**TOWN OF NEWBURGH  
PLANNING BOARD  
TECHNICAL REVIEW COMMENTS**

**PROJECT NAME:** HILLSIDE LAND DEVELOPMENT  
**PROJECT NO.:** 22-27  
**PROJECT LOCATION:** SECTION 34, BLOCK 2, LOT 66/24 JEANNE DRIVE  
**REVIEW DATE:** 28 APRIL 2023  
**MEETING DATE:** 4 MAY 2023  
**PROJECT REPRESENTATIVE:** FELLENER ENGINEERING, LLP

**TOWN OF NEWBURGH FIRE PROTECTION**  
**FLOW TO BLDG. CONNECTION DETAIL**

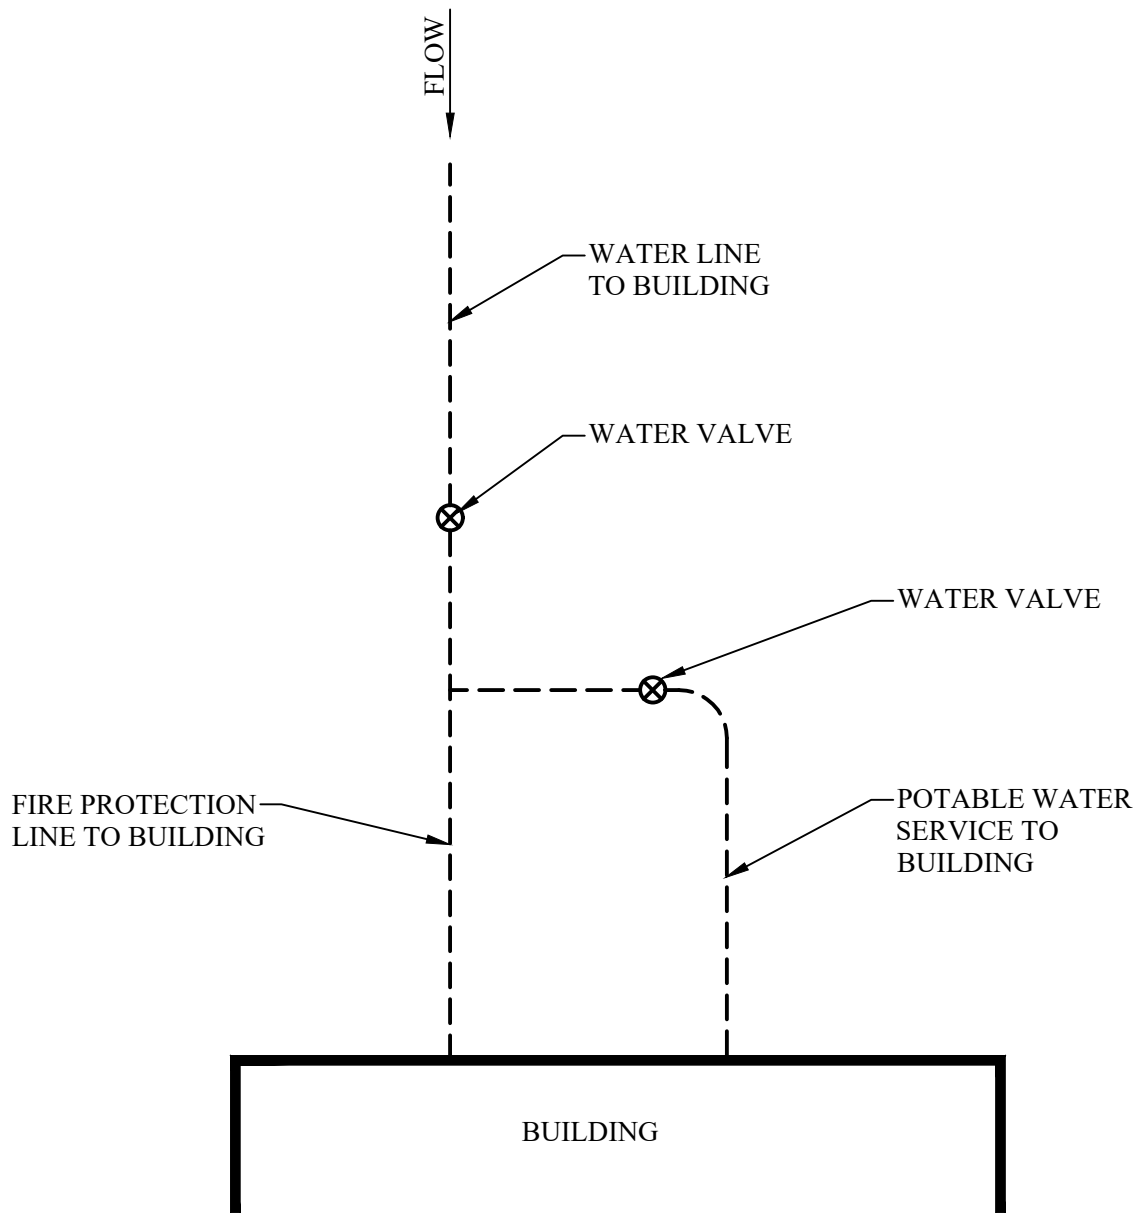
11. The water service valving for the project site should be per the Town Standard Detail, copy attached. This detail requires potable water to be terminated if fire protection water is

terminated.

### 1 LANDSCAPING PLAN & EROSION & SEDIMENT CONTROL PLAN

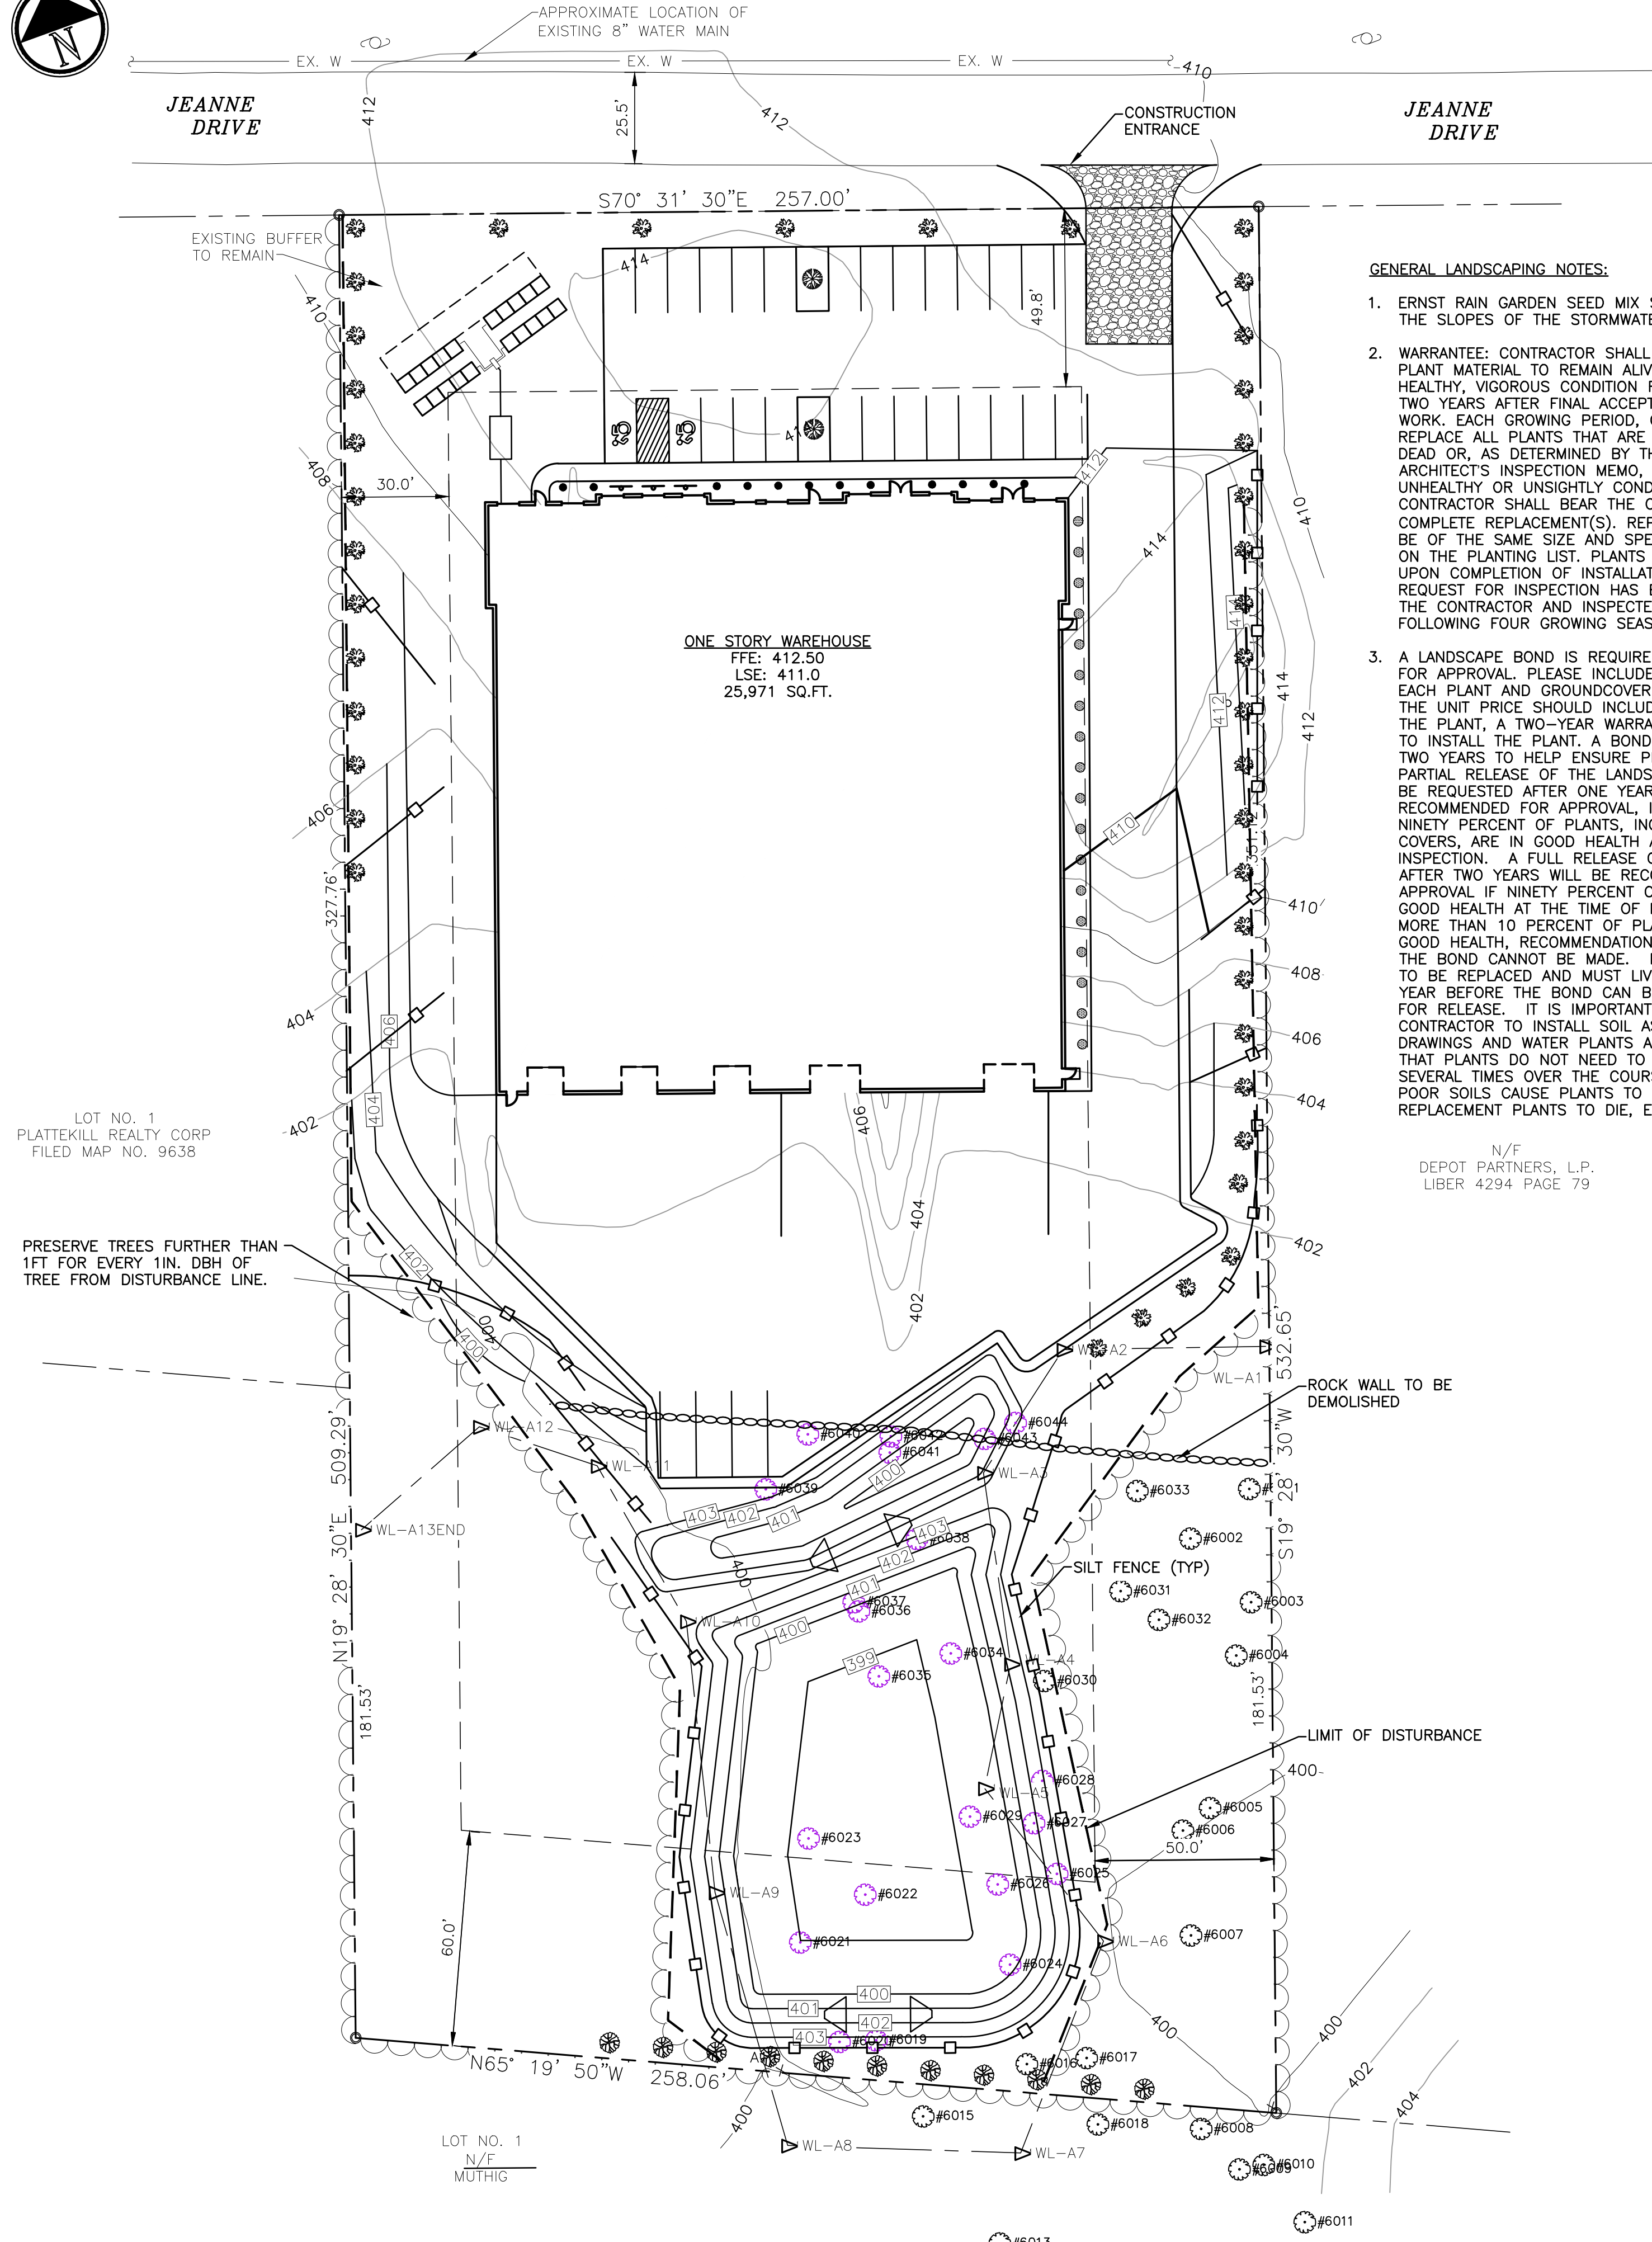
5. Article V, Section 185-21 gives the planning board authority to require reasonable screening of parking and service areas from other properties and in the rear of the property where a residential project is proposed. We recommend dense screen planting between the site and all abutting properties. Screen planting between commercial uses should be deciduous trees because many deciduous trees tolerate compacted soils better than evergreens. They also do not get browsed by deer.

6. According to Town of Newburgh design guidelines, street trees must be shown planted 40' on center along the road. There is no reason street trees cannot be shown for the length of the northern property line along Jeanne Drive. Please show native street tree species such as Red Maples or Pin Oaks 40' on center for the length of the property line along the road.

9. Show water-loving trees planted along the south bank of the pocket pond such as Swamp White Oaks. The Oaks will provide further screening of the site from the proposed residential project to the south and keep their leaves for longer in the winter.

12. Norway Spruces are shown with Maples along the east property line. In our experience evergreen trees struggle on commercial sites in this area. Instead, consider a large-growing deciduous tree species, ideally a species found in the nearby wooded areas, if urban tolerant in areas where soil will likely be compacted. Plant closely together, about 15' on center or so along the property line to form a forested boundary. Planted this close, screening should occur within 10 year of planting and deciduous trees will provide more ecological benefits than the evergreens.

*FE Response: Deciduous trees are now proposed along each property line for screening. See sheet C-701.*

*FE Response: Red Maples are currently shown along the front property line spaced at 40' on center. See sheet C-701.*

*FE Response: A row of swamp white oaks have been added along the south bank of the pond. See sheet C-701.*

*FE Response: The red maples proposed along the front of the property are now also shown extending down the east property line, 15' on center. See sheet C-701.*
